CITY OF ALBUQUERQUE

RE: Pool Addition
4904 Northern Trl NW
Grading and Drainage Plan
Engineer's Stamp Date: 3-27-2025
Hydrology File: F11D017C

Based upon the information provided in your submittal received 03/29/2026, the Grading and Drainage plan is **not approved** for Building Permit and Grading Permit. The following comments need to be addressed for the approval of the above referenced project.

4904 NORTHERN TRAIL, NW, POOL ADDITION GRADING AND DRAINAGE PLAN

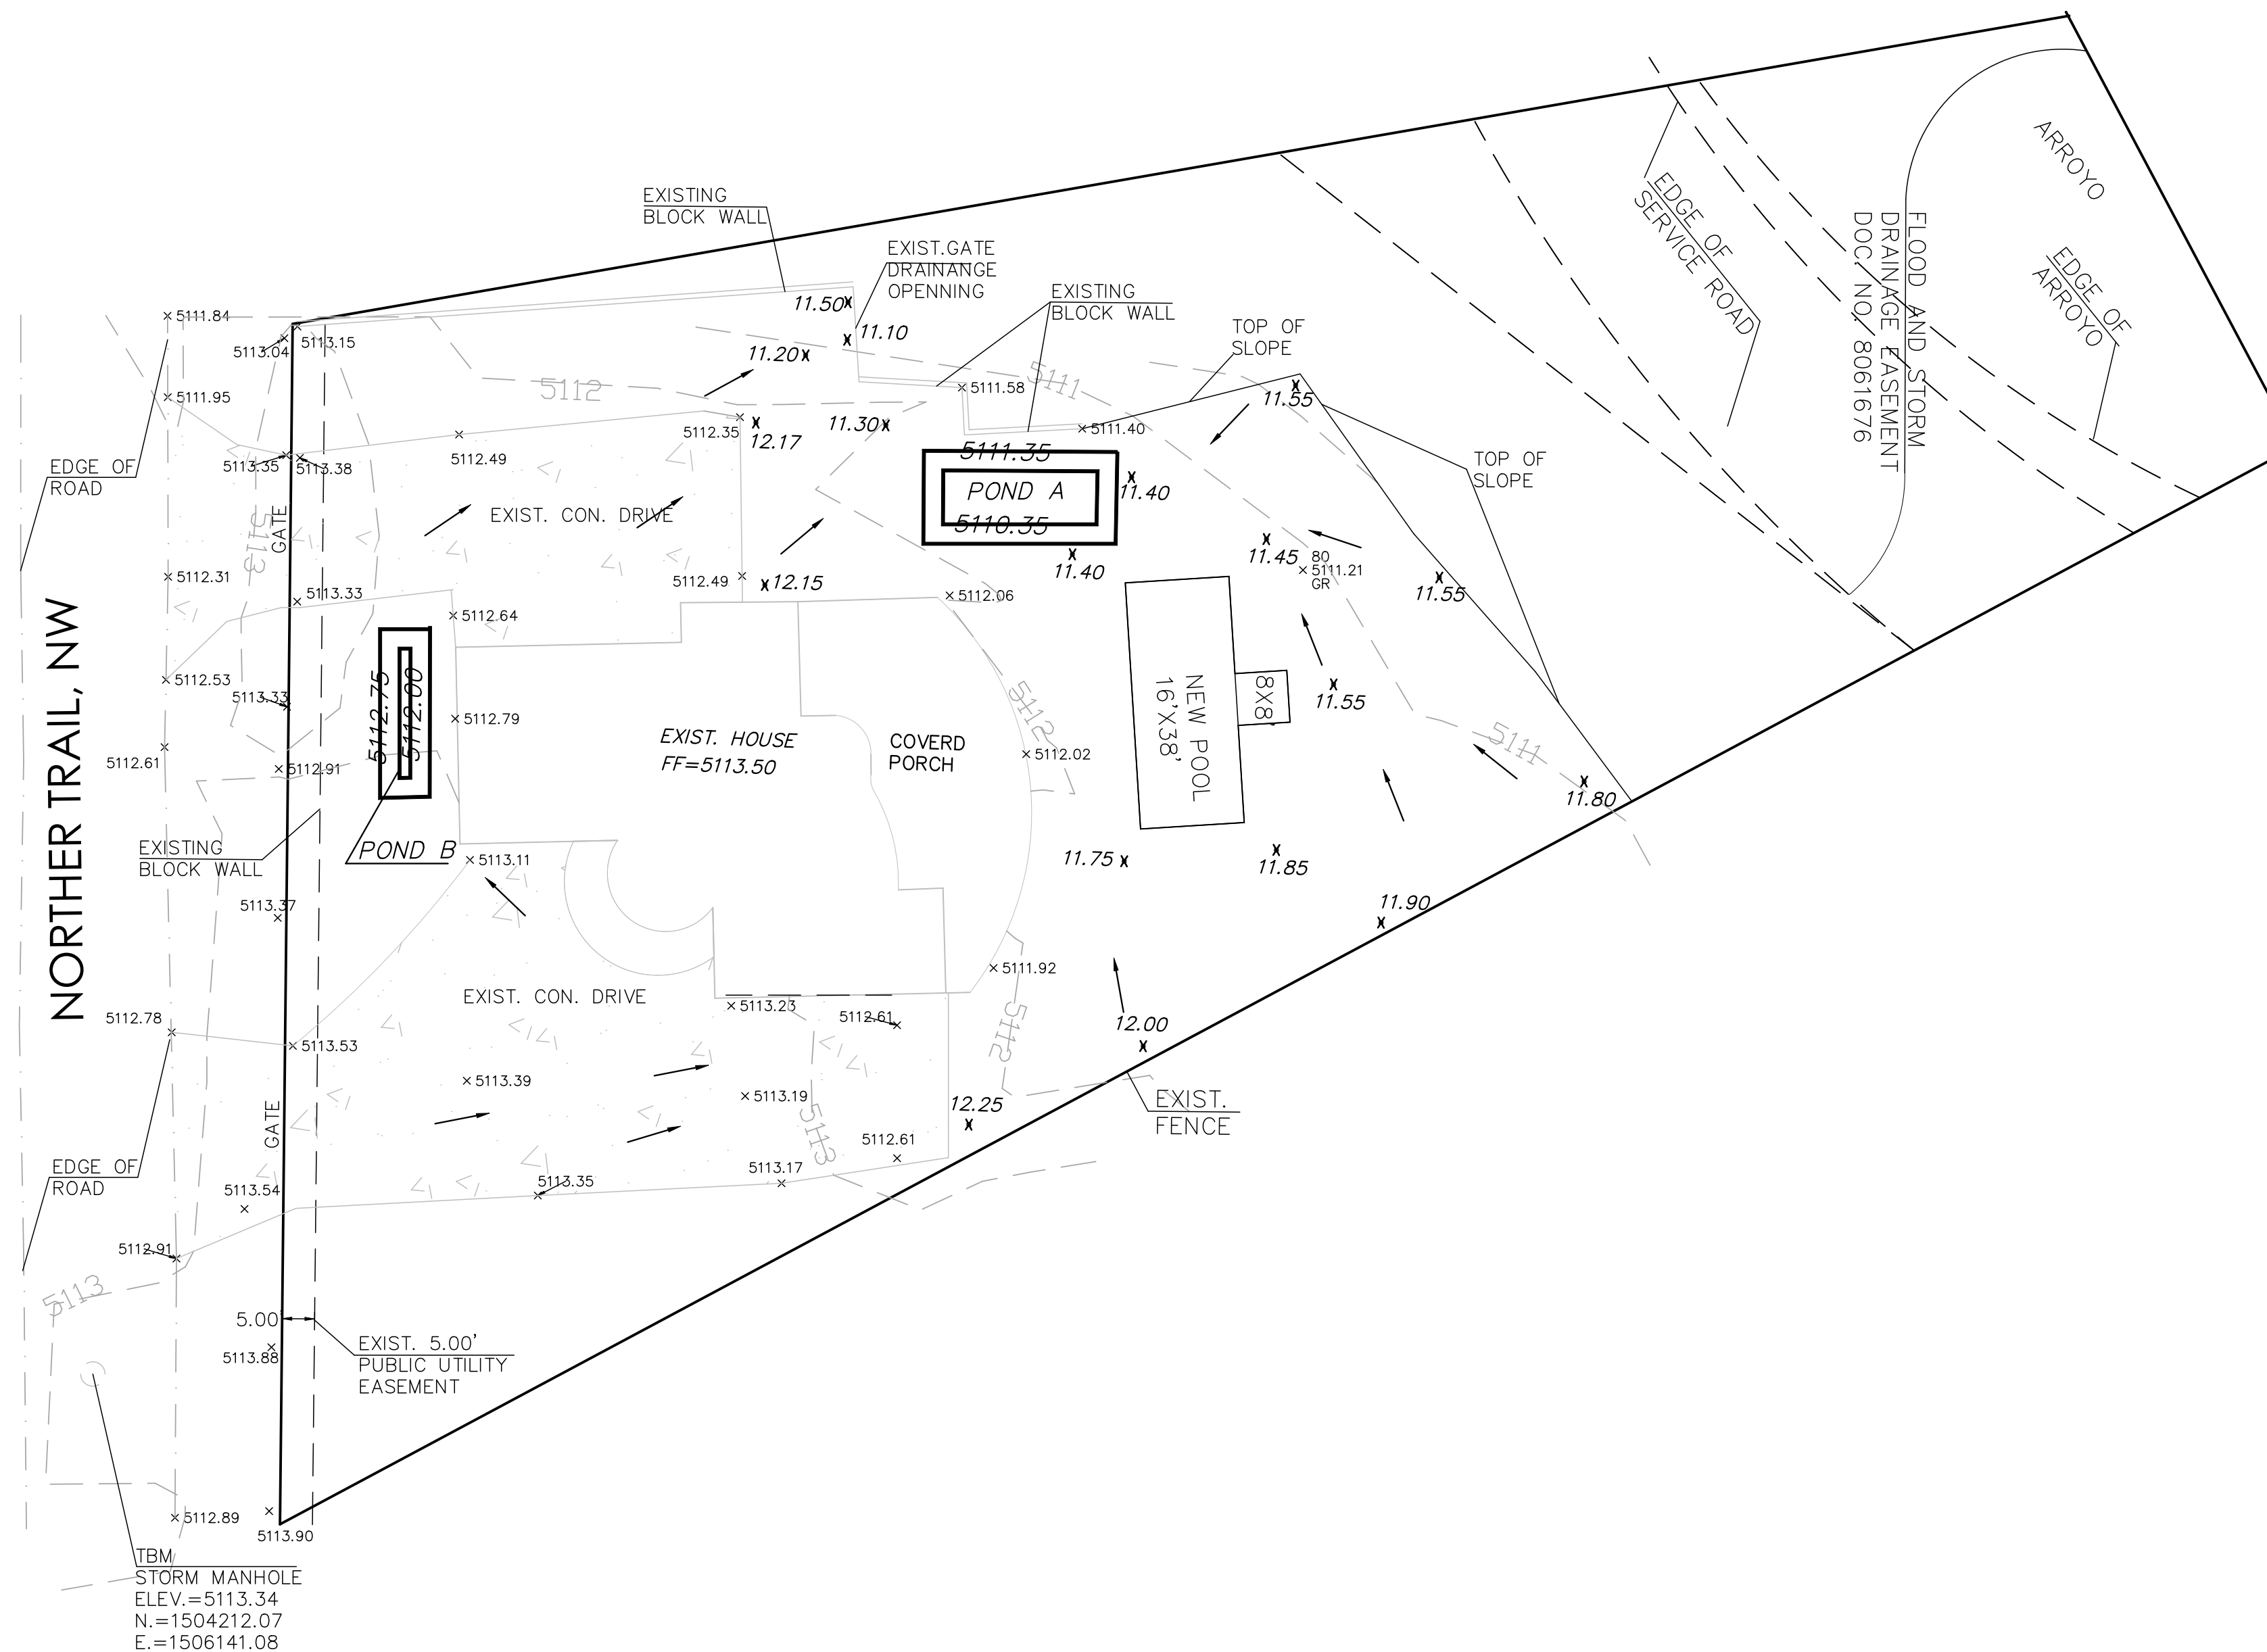
1. Since this project is adjacent to, or drains into an Albuquerque Metropolitan Arroyo and Flood Control Authority (AMAFCA) facility, approval by AMAFCA will be need prior to Hydrology approval. Please contact Jared Romero P.E, CFM (jromero@amafca.org or 505-884-2215).

2. Please add a note under Grading Notes. "Side slopes need to be stabilized with Native Grass Seed (per City Spec 1012) with Aggregate Mulch or equal (Must satisfy the "Final Stabilization criteria" CGP 2.2.14.b.)". (Unless AMAFCA requires use of their spec. for the area east of the Top of Slope.)

3. Per the IDO 5-6(E)(1)(a), Landscaped edge buffers and/or edge buffer walls are required between properties to mitigate the impacts of significant differences in property use, size, or scale through standards specified. Please show this on plan where the home and the drainage easement use changes.

4. Per the IDO, the property owner of the property is responsible for building the adjacent half of Northern Trail NW to include curb & gutter, and sidewalk. The project will have to go to the Development Facilitation Team (DFT) for approval of the Infrastructure List or approval of a waiver from the DHO.

5. A portion of this project is located in a floodplain (AE) and a floodplain development permit must be obtained.
6. Please provide the Benchmark information (location, description, elevation, **and datum used**) for the survey contour information provided.

7. There is erosion along the north side of the lot. Show on the plan how this area will be corrected to prevent erosion over time along this flow path.
